NOV\_SCE\_ATJ\_ 20211201-01

## **NOTICE OF VIOLATION**

# Energy Safety Inspection Report

Report Name: ATJ\_SCE\_20211201-01

Structure ID: 4278547E

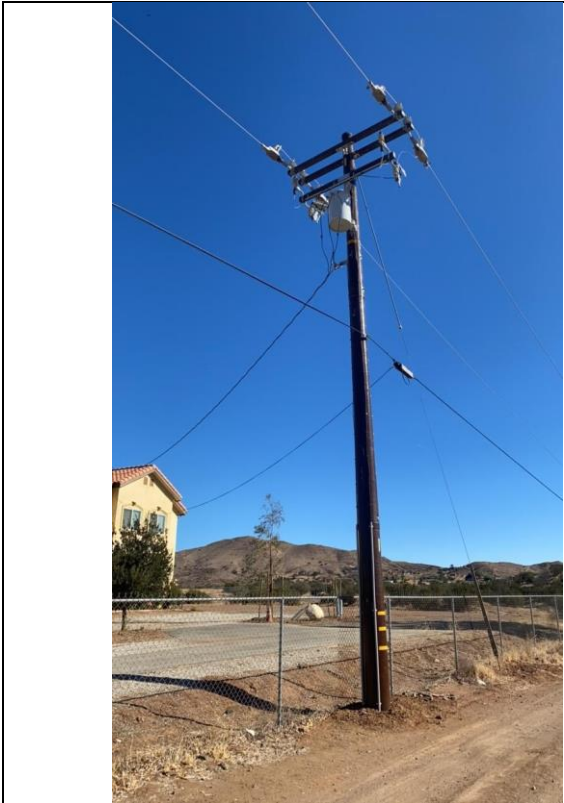
<p><b>Item11IA1img1:</b> No vibration dampers</p>

Structure ID: 4278546E

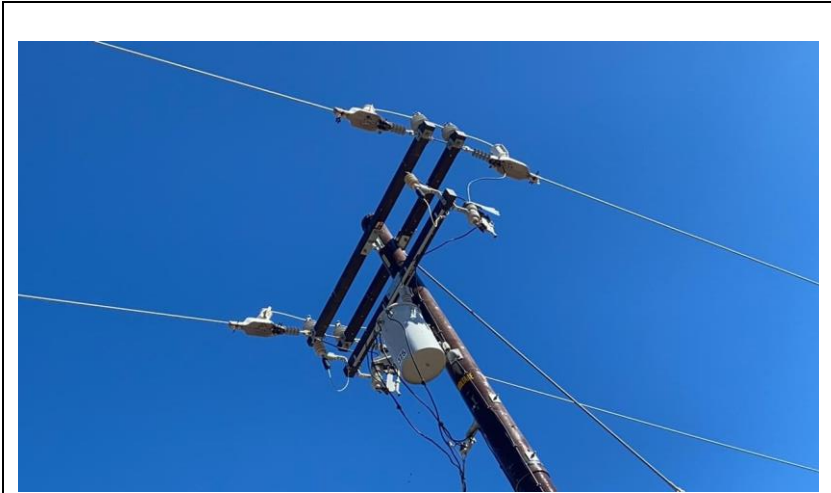
Item12IA1img1: No vibration dampers

**Structure ID: 4373743E**

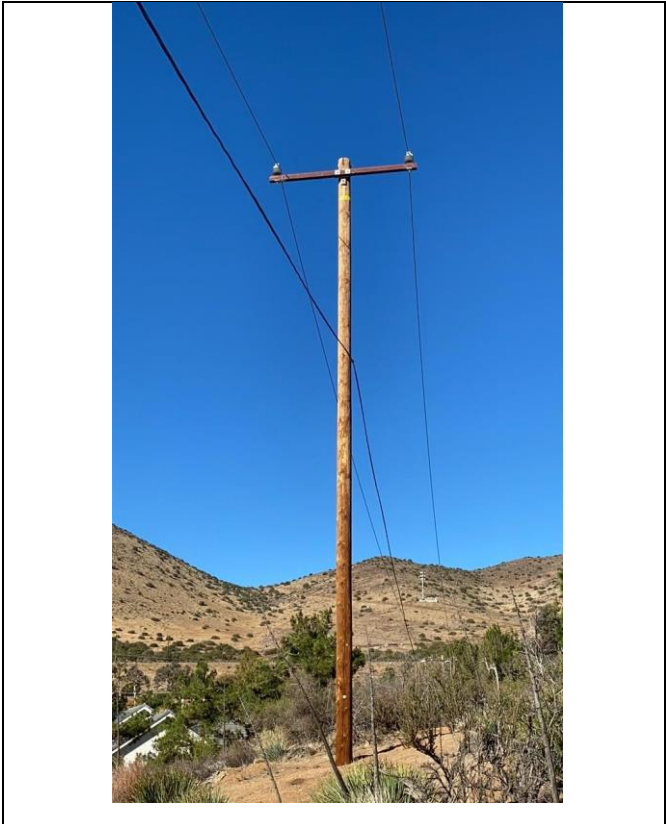
**Item17IA1img1: No vibration dampers**
